Clarification of Dissenting Opinion

FAR/JAR 25.671 FCHWG - ARAC Report

(Includes Rule, Advisory Material, & Alternate Recommendations)

APPENDIX 2. EXAMPLES OF 25.671(c)(2)'s 1 in 1000 REQUIREMENT.

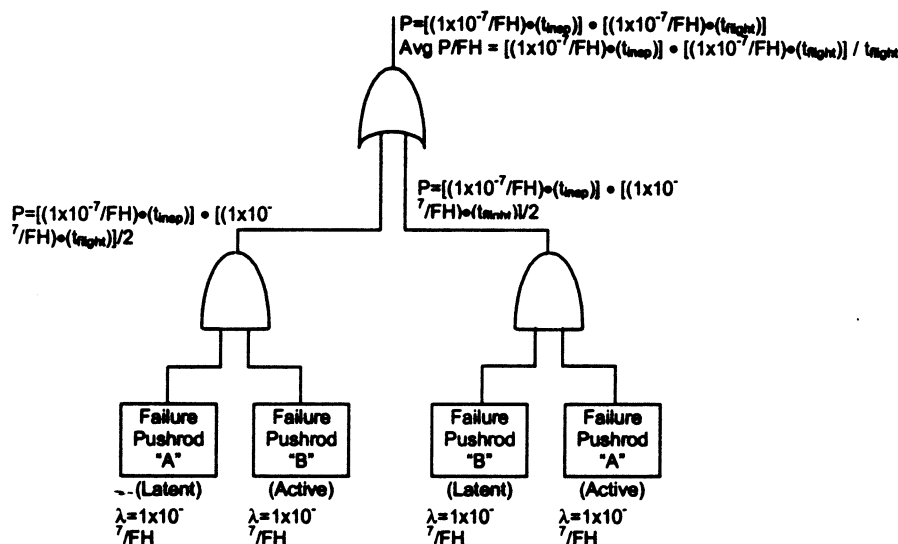
The following simplified examples explain how the additional 1 in 1000 requirement in FAR/JAR 25.671(c)(2) might be applied. Since many other factors influence the acceptability and certificability of a design, inclusion of a design as an example does not imply the design will always be acceptable; the examples below are only included to illustrate the additional investigation required under FAR/JAR 25.671(c)(2).

b. Example #2 – Flap System and Asymmetry Detection.

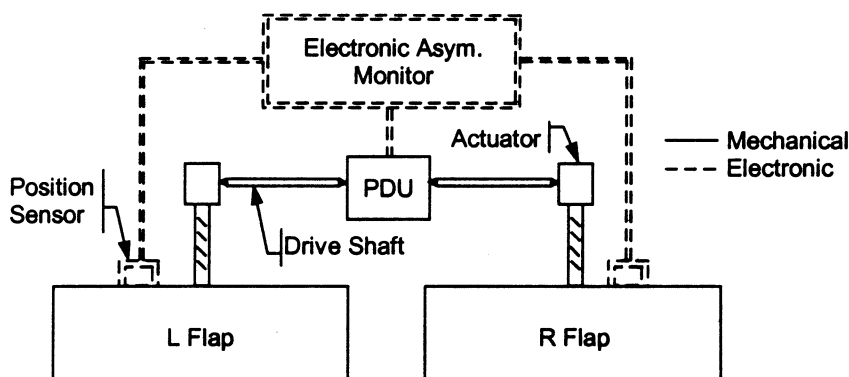
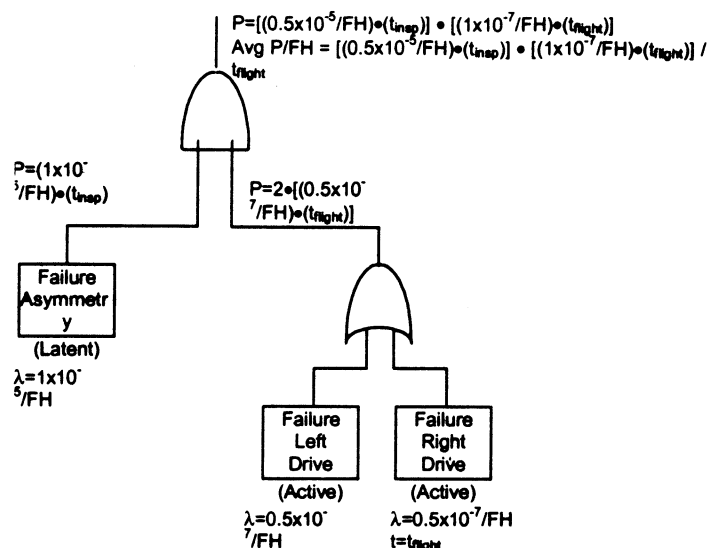
Although there are other requirements that govern such a design, consider the simplified flap drive system shown. Assume that excessive asymmetry could preclude continued safe flight and landing in any flight phase; therefore, excessive asymmetry must be sufficiently guarded against throughout the flight (i.e., at risk time could not be used in this case).

In this example a central power drive unit drives, through drive shafts, irreversible actuators at the flap surface. In the absence of the asymmetry monitor, a severance of the drive shaft just outside the PDU results in one flap being driven and the other flap remaining in its last commanded position – excessive asymmetry could develop. Since this excessive asymmetry is not extremely improbable, an electronic flap asymmetry monitor checks the position of each flap and shuts down the power drive unit should excessive asymmetry start to develop. The asymmetry monitor is passive; it only shuts down the PDU when it detects an excessive asymmetry.

- (1) FAR/JAR 25.1309 Considerations -- Suppose the manufacturer has sufficient service history data to justify the probability of either drive shaft severance is approximately $1 \times 10^{-7}/\text{FH}$. Under a strict FAR/JAR 25.1309 approach, to ensure that excessive flap asymmetry is extremely improbable the likelihood of either drive shaft severance combined with the likelihood of an asymmetry monitor failure would need to be less than $1 \times 10^{-9}/\text{FH}$.

Suppose the manufacturer has sufficient service experience with similar electronic monitor systems to justify a failure rate (fail to inoperative status) of $1 \times 10^{-5}/\text{FH}$. In the example, the failure of the monitor is dormant since the monitor takes no action until it detects the asymmetry; therefore, a periodic check is established to satisfy the required minimum reliability for 25.1309.

Since the 2000 hr inspection interval for compliance with FAR/JAR 25.1309 does not satisfy the 1 in 1000 criteria in the second part of FAR/JAR 25.671(c)(2), a design change would be necessary. Options available include: (1) change the monitor to self-check so it is no longer a dormant failure, (2) change to a redundant drive path or redundant monitor path, (3) improve the reliability of the monitor, or (4) reduce the check interval on the monitor. For this example, let's recalculate the inspection interval to comply with the 1 in 1000 criteria.
